Addendum NO.02

Bid Question Responses

ARENA LOFTS
LINCOLN, NE.
PROJECT NO. 10216

April 10, 2013

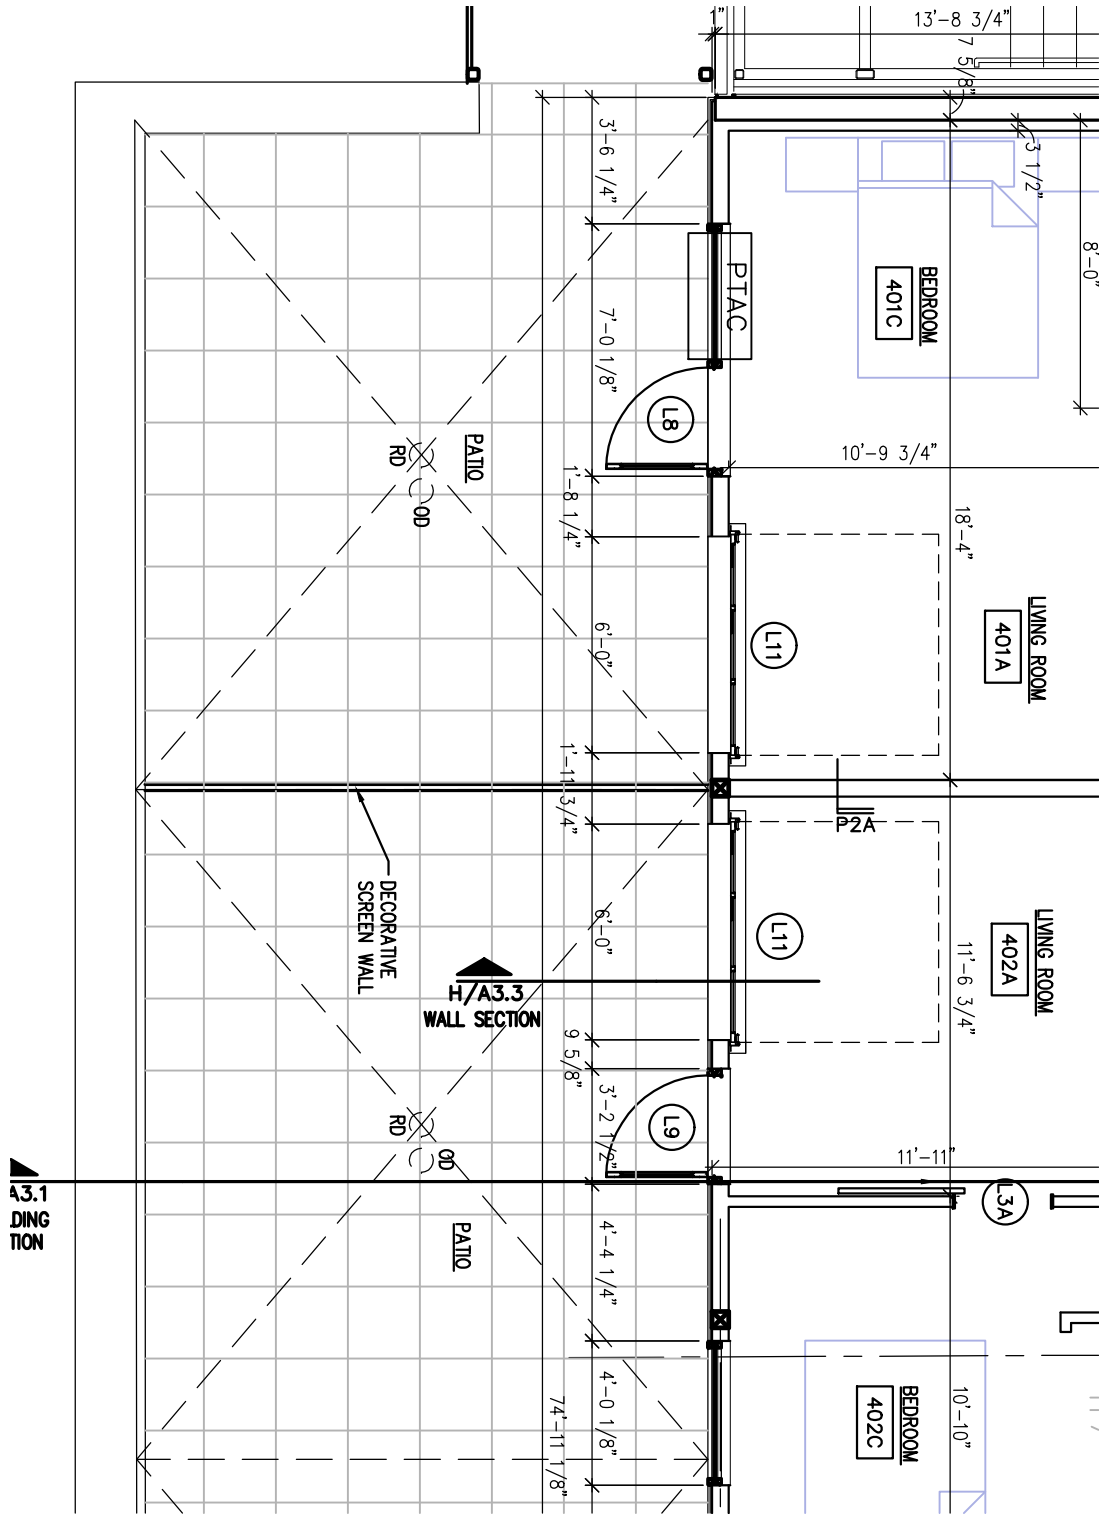
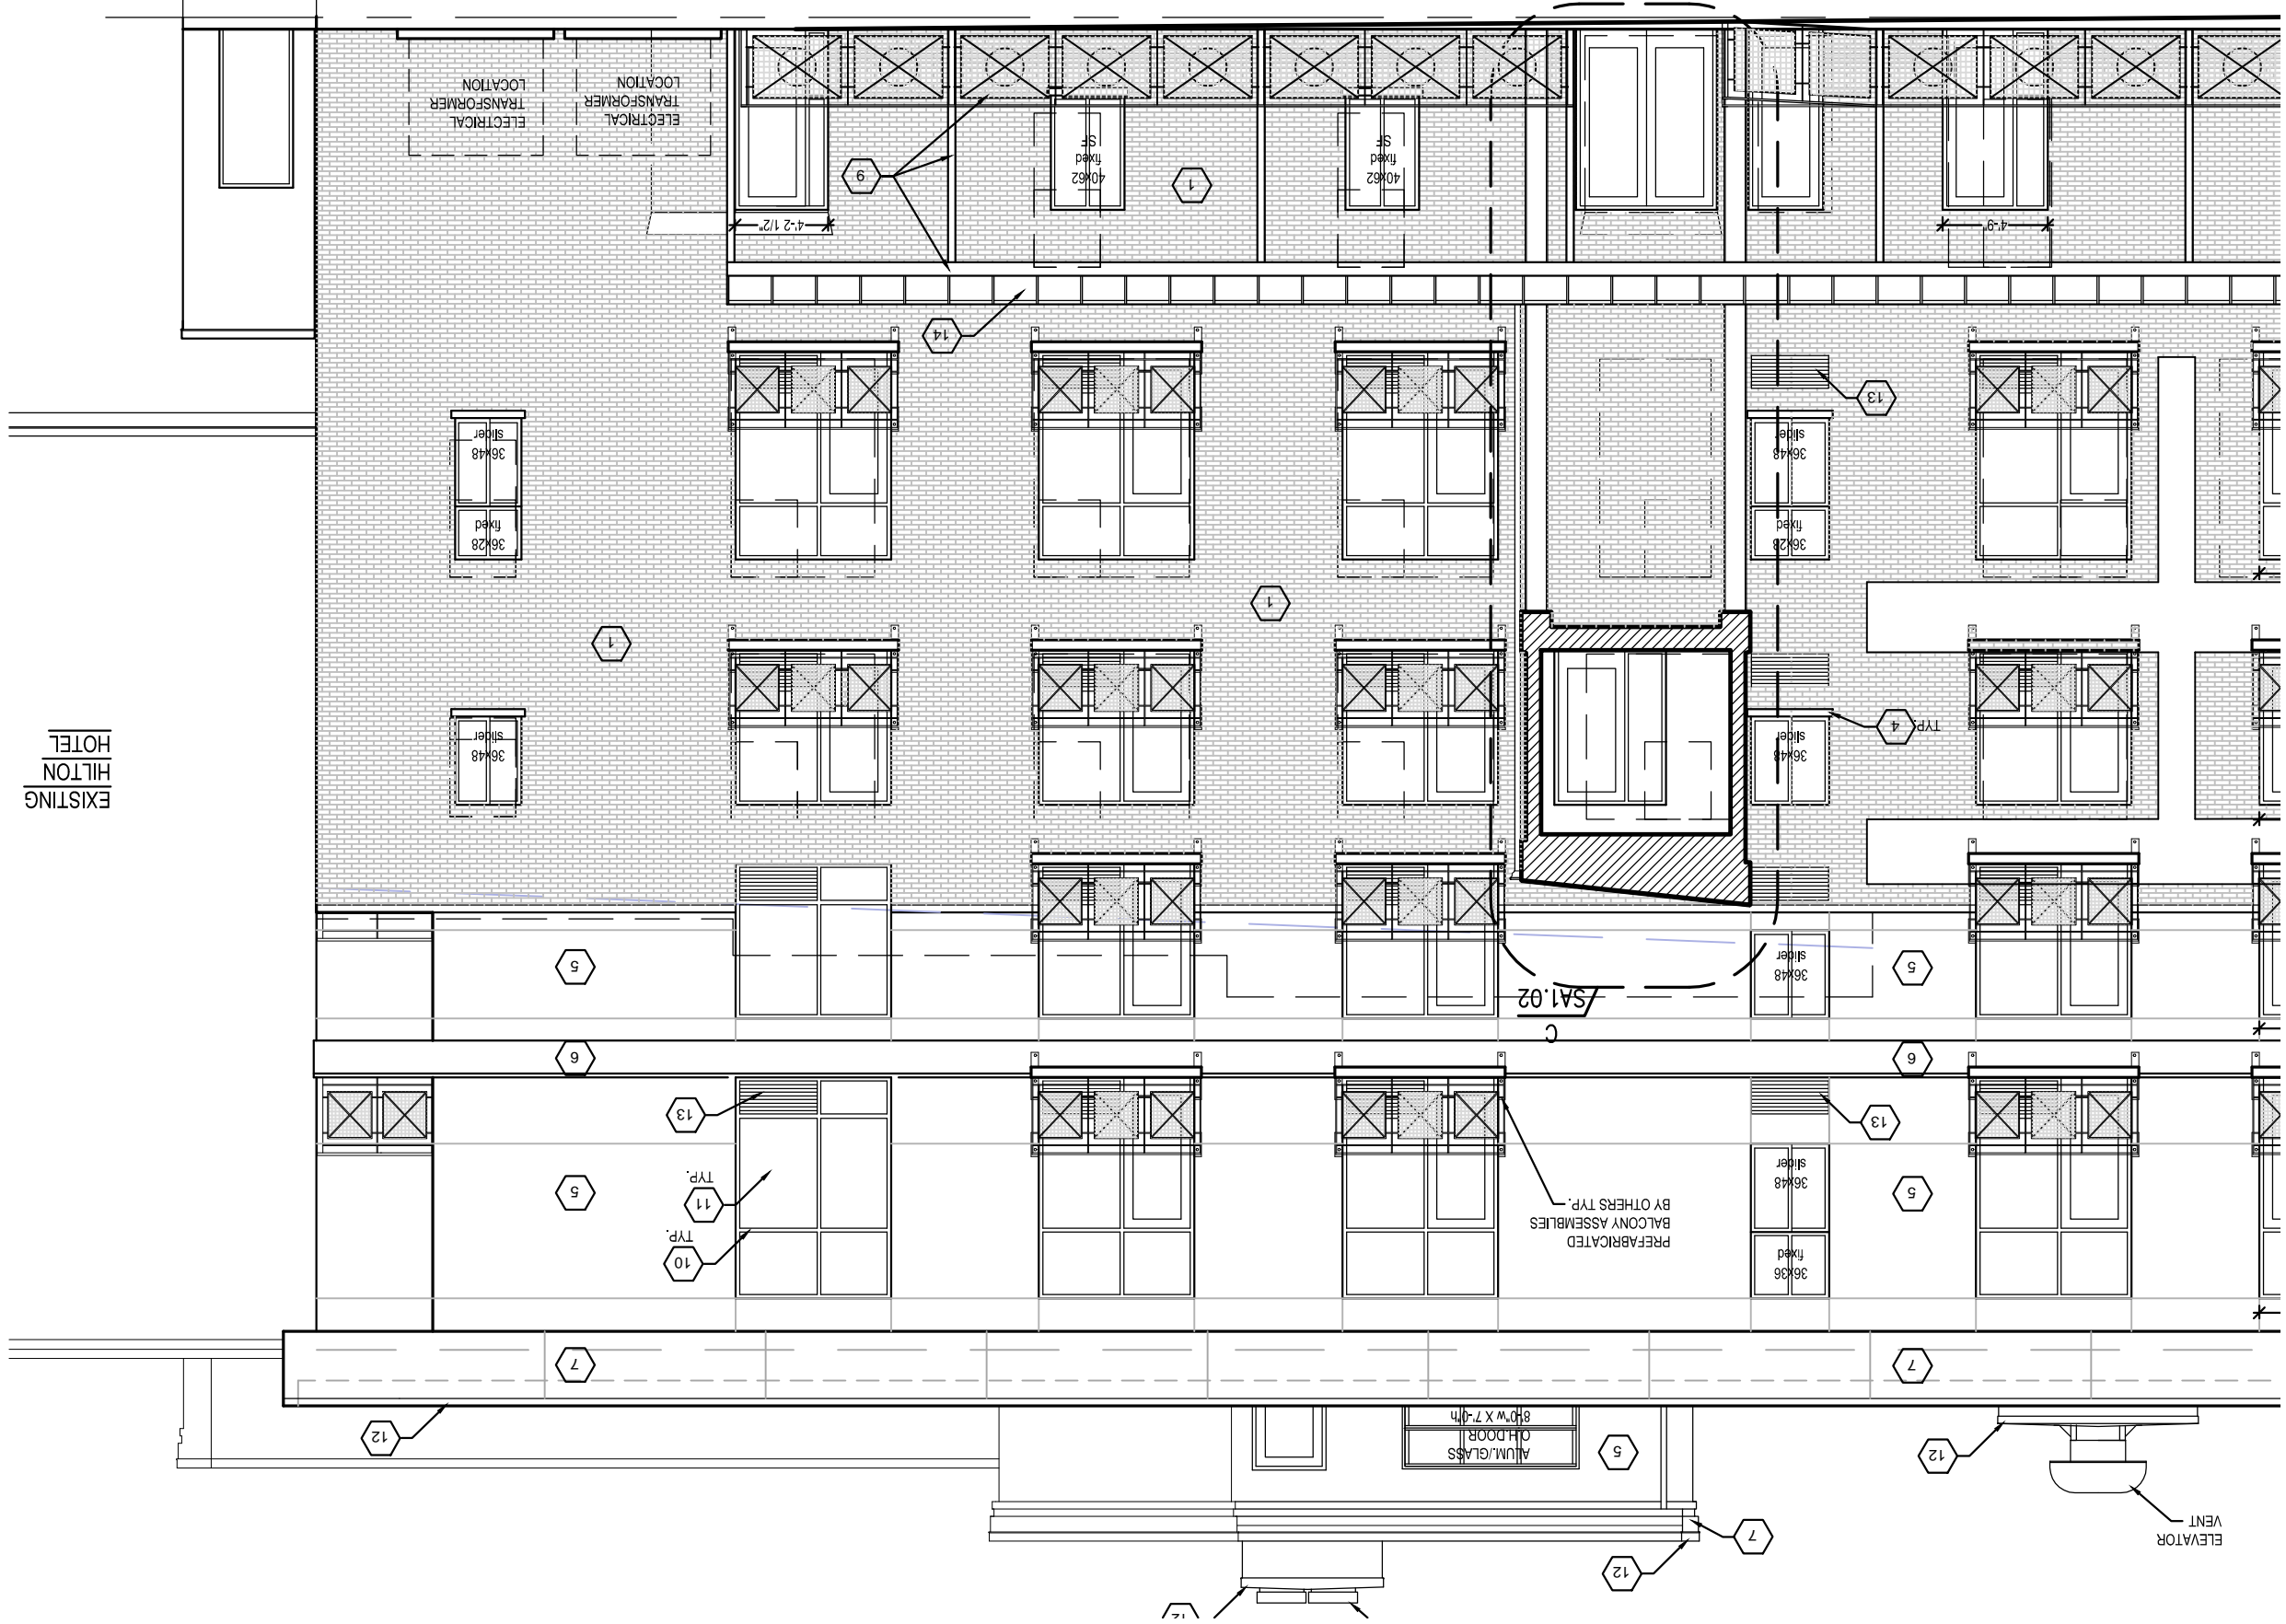
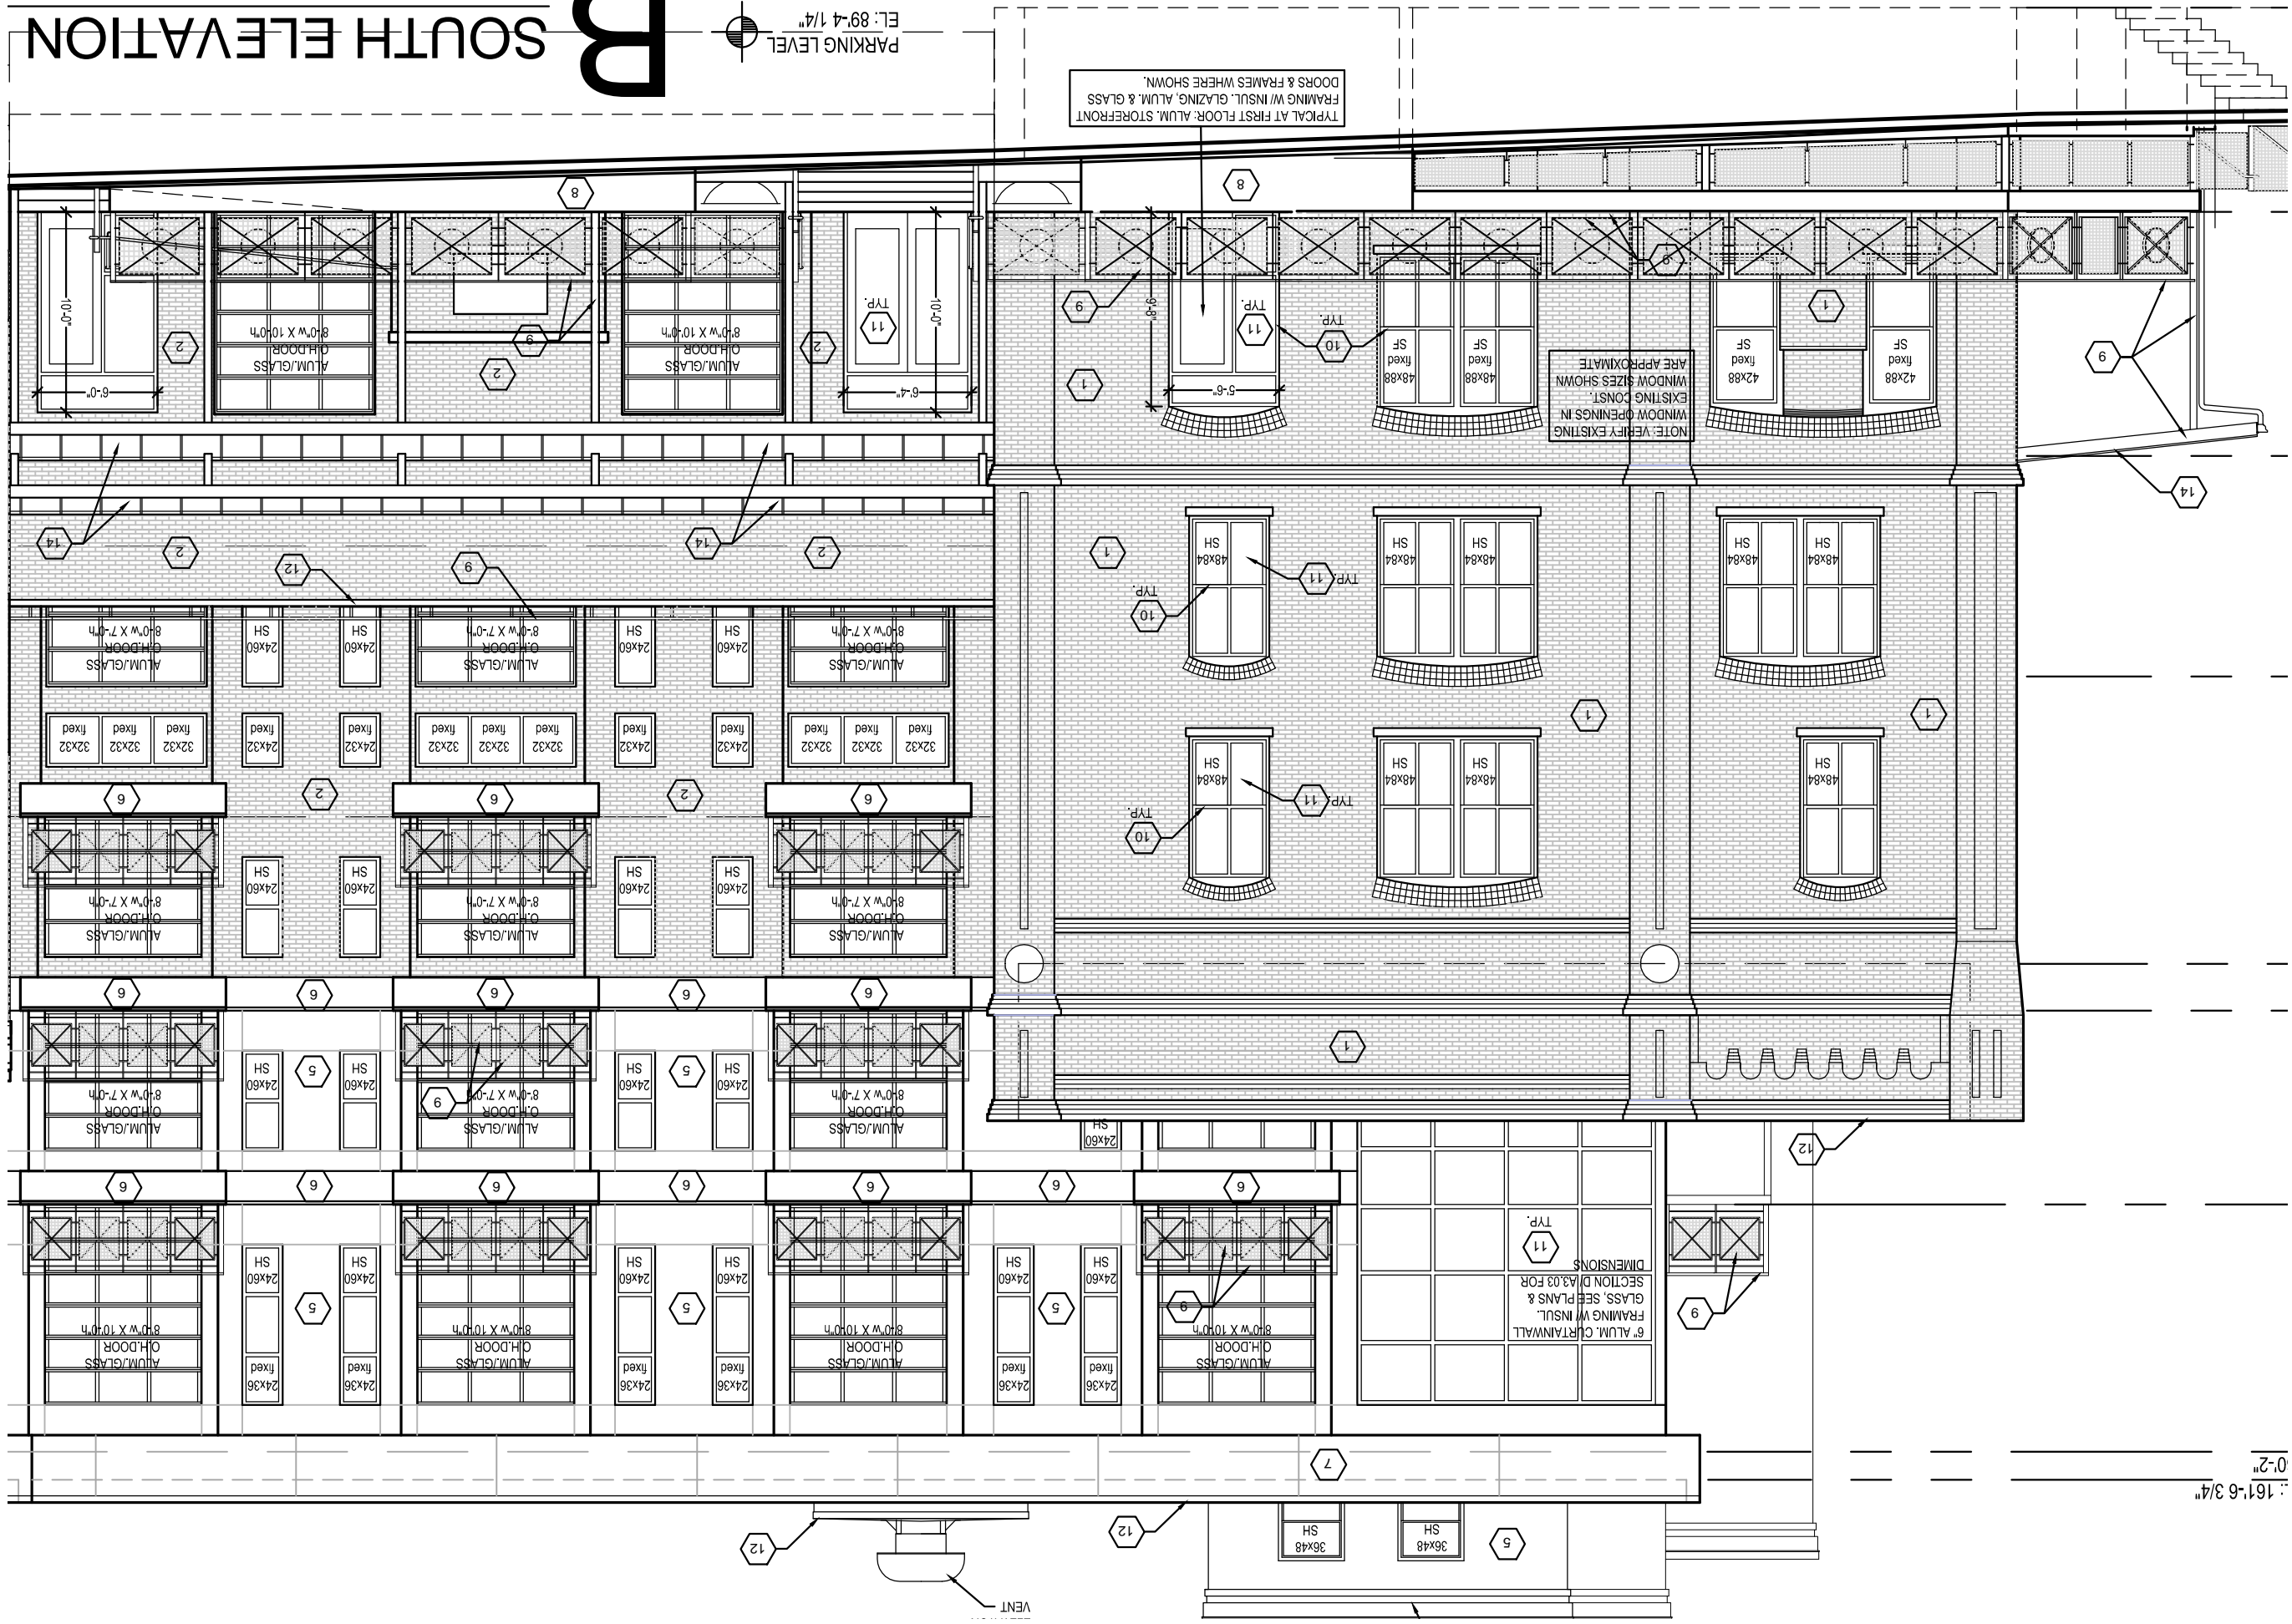
- Floor drains shall be installed at roof decks. See attached sketches.
- Window sizes are shown in the attached sketches.
- Floor trusses shall be insulated full height with fiberglass insulation.
